# CERTIFICATE OF APPROPRIATENESS PLACARD

520 N BLOUNT STREET

170-15-MW

COA Minor Works Application: 520 N Blount St.

Addition of Exterior Lighting, Ceiling Fans and Screens on Rear Porches:

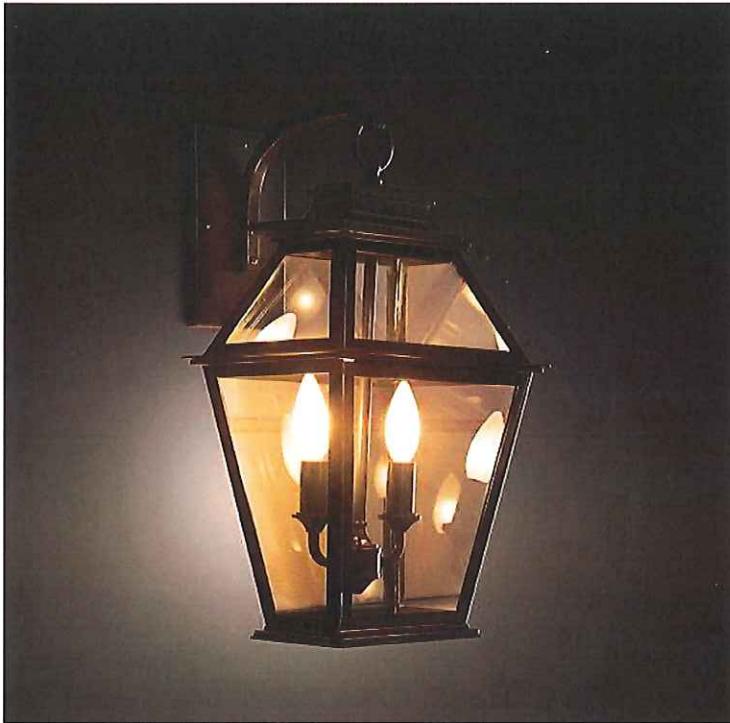
- Please confirm that the screening of the porches will be inside the railings/posts and wood framed. If you do not have a drawing, then a photo of the sample screening method is needed.
- Provide some clarity on the size (height and width) of the light fixtures.
- It also looks like fixtures are proposed on the outer-side of the front columns, which would not be appropriate. Lights are traditionally on the walls of houses, not the columns.

- Please confirm that the screening of the porches will be inside the railings/posts and wood framed. If you do not have a drawing, then a photo of the sample screening method is needed. **Screening will be inside the posts/railings. We have not made the exact screening selection at this time but will submit a photo and rendering of the screening and door when the selections are made and before they are purchased for prior approval.**

- Provide some clarity on the size (height and width) of the light fixtures. **Dimensions for the light fixtures are included in the application below their individual pictures.**
- It also looks like fixtures are proposed on the outer-side of the front columns, which would not be appropriate. Lights are traditionally on the walls of houses, not the columns. **The fixtures are being proposed on the wall of the house, not on the outer portion of the column. Sorry for the confusion, they are blocked by the columns in the elevation so I placed them atop the columns as if you could see through them to where they will be on the wall.** ✓

NEW LANDSCAPE PLAN

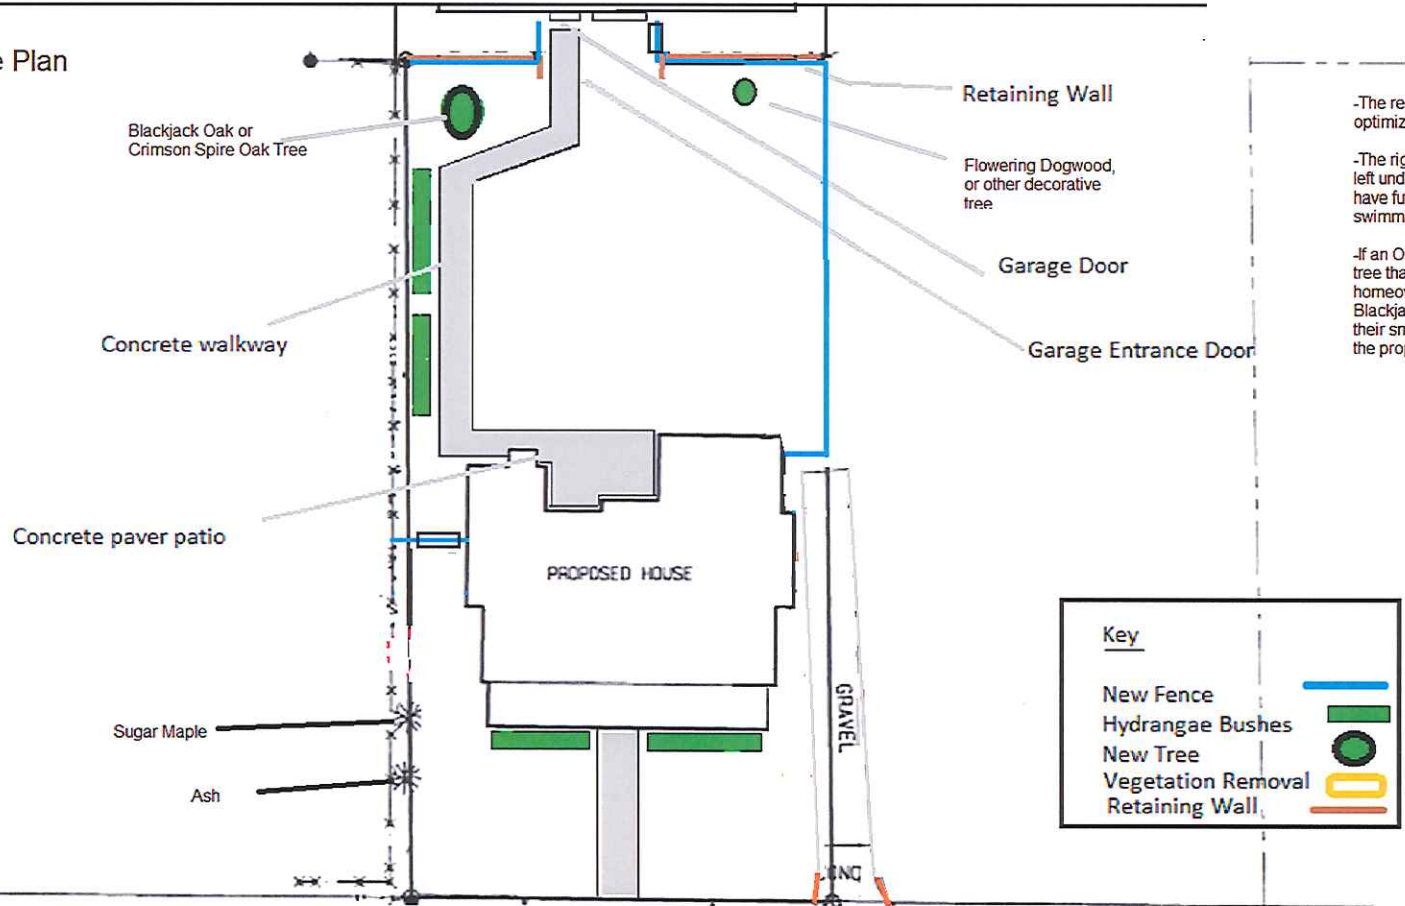
- Please send in additional pictures of the front-yard (showing house and front property), the rear of the building, and side of the building for which work is proposed.
- In addition, on the landscaping plan please show the extent of the current driveway and proposed driveway and add dimensions for that element.
- Please include any specs you have for the gate materials.
- Please include specs or a picture of a similar door to the one you are proposing for the rear screened porch.

Attached is an updated landscape plan with a driveway division between the new and old driveways including distances for each. The picture of the driveway that I previously sent you is a bit deceptive. New gravel has been added during construction to support the additional vehicles and deliveries. The new gravel makes it appear that the driveway ends at the midway of the side of the house. The original gravel driveway actually extends to the beginning of the chain link fence.
